S. Bellaire
File No: SP12-004340

TO:	CHAIR AND MEMBERS – PLANNING AND ENVIROMENT COMMITTEE MEETING
FROM:	GEORGE KOTSIFAS DIRECTOR OF BUILDING CONTROLS AND CHIEF BUILDING OFFICIAL
SUBJECT:	APPLICATION BY: DIOCESE OF LONDON 806 VICTORIA STREET PUBLIC SITE PLAN MEETING MARCH 26, 2012 after 4:10 PM

The purpose of this application is to obtain site plan approval for the construction of 274 crypts including one storage room on lands known municipally as 806 Victoria Street within the existing St. Peter's Cemetery. In accordance with the Cemeteries Act (S3.4), the municipality may hold a public meeting to determine if the approval is in the public interest.

Proposed Exterior Elevations

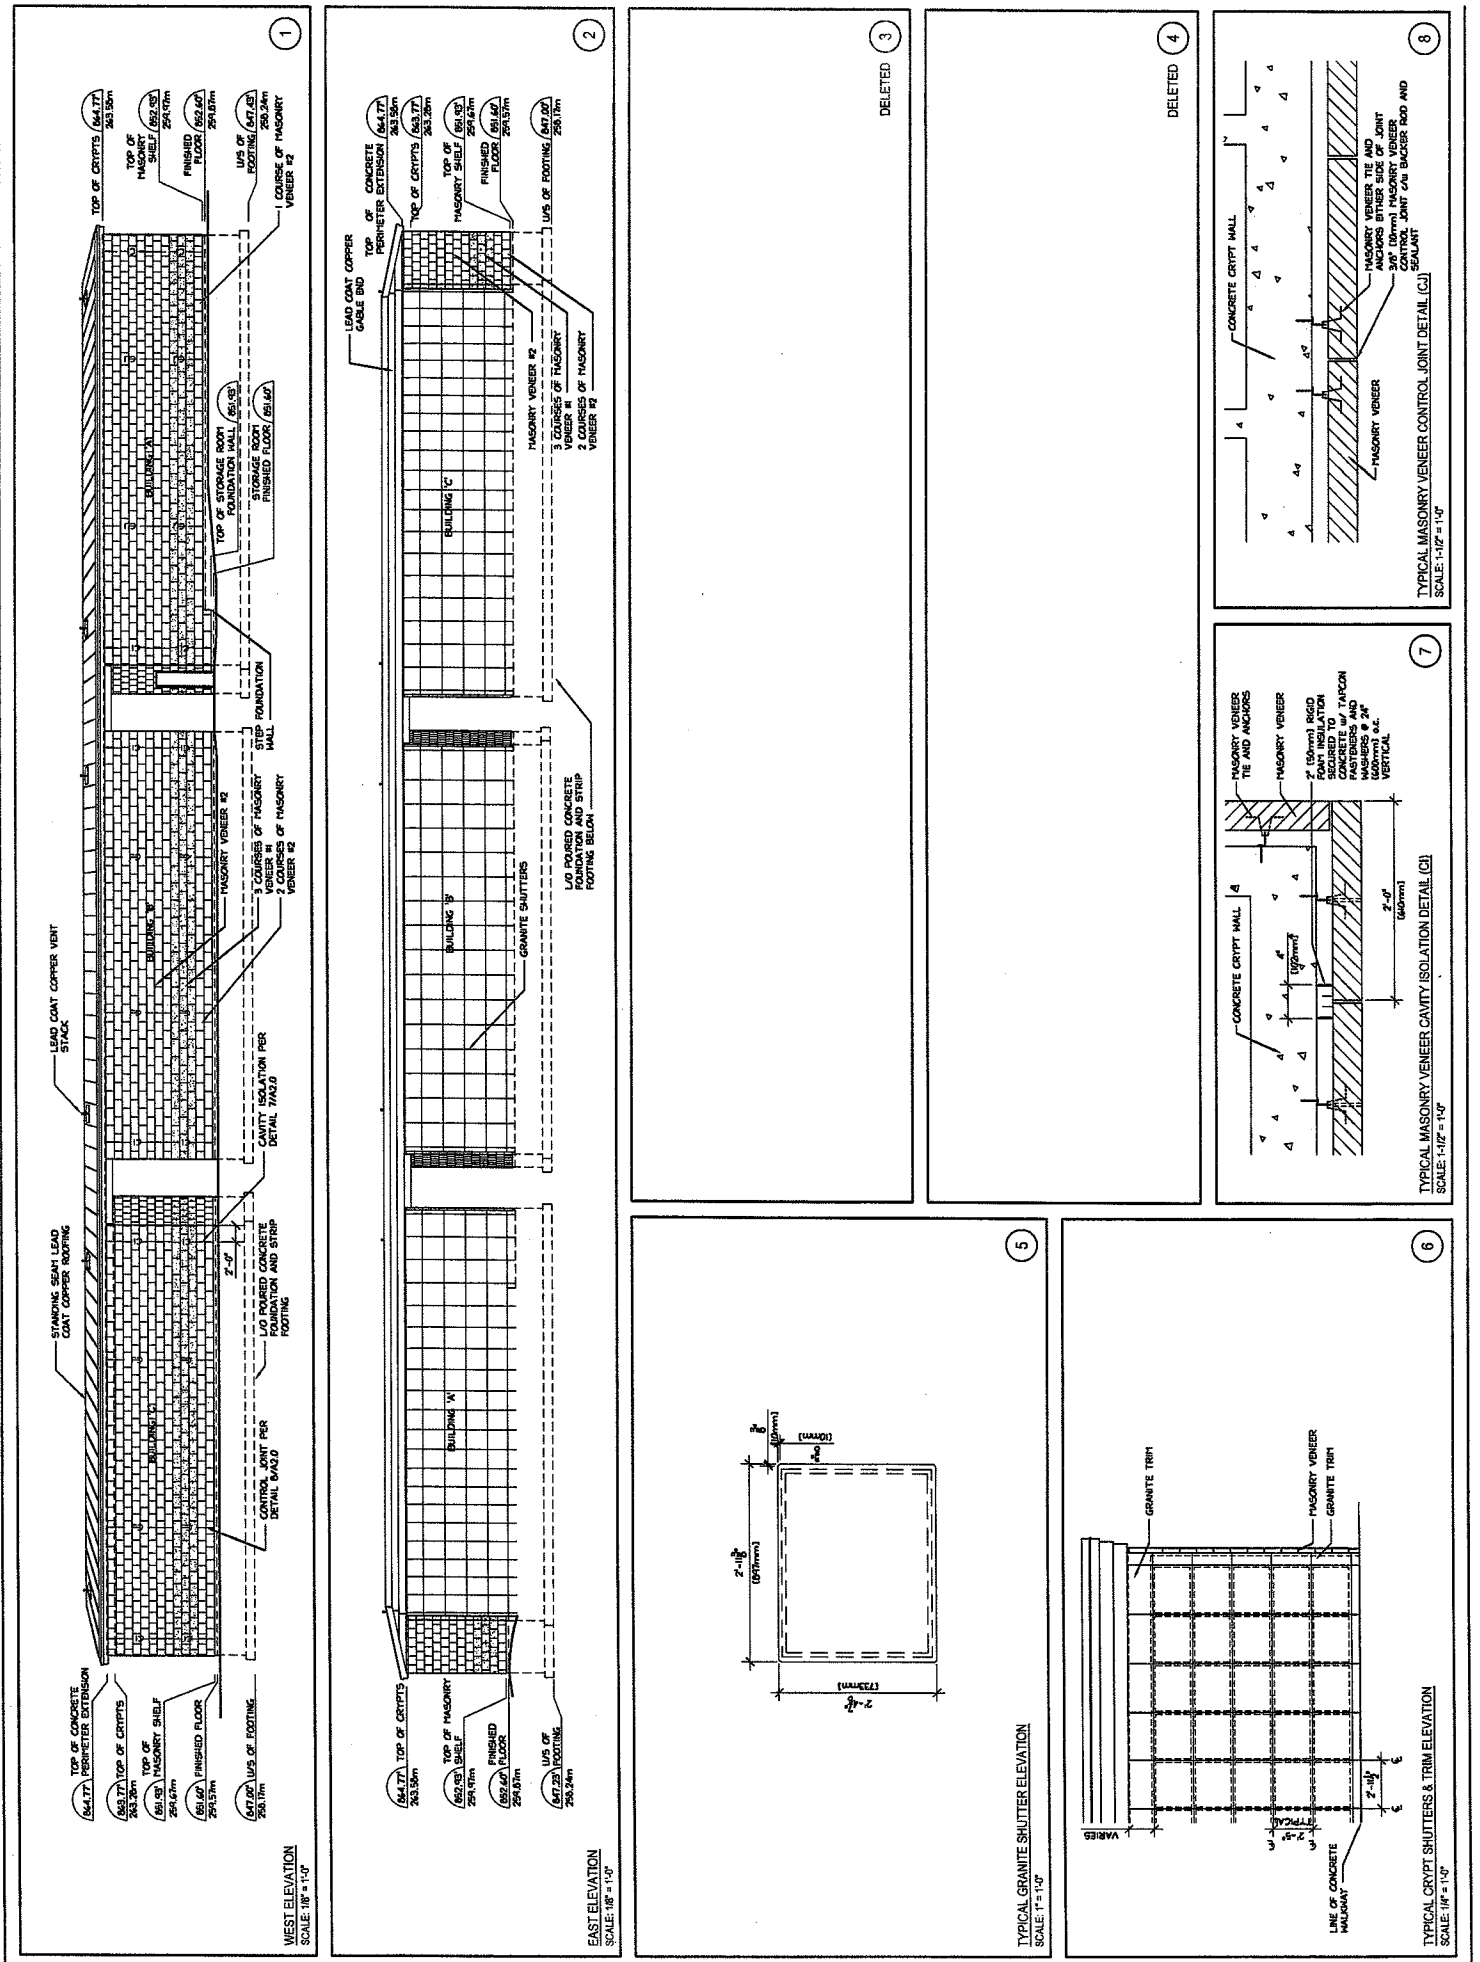
The subject lands are currently used for the existing St. Peter's Cemetery which includes a mausoleum structure. The proposed crypt building is to be located northwest of the existing mausoleum and is proposed to be only 4.68m in height. There are a large amount of coniferous and deciduous trees and shrubs on the property making it difficult for this proposed structure to be visible from any of the streets surrounding the subject property. Properties in the area contain a mix of residential housing types and the proposed development will maintain the character of the area. The proposed crypt building conforms to the regulations of the Open Space (OS3) Zone. Through the site plan review process, the Community Planning and Urban Design group indicated they had no concerns with the character of the building.
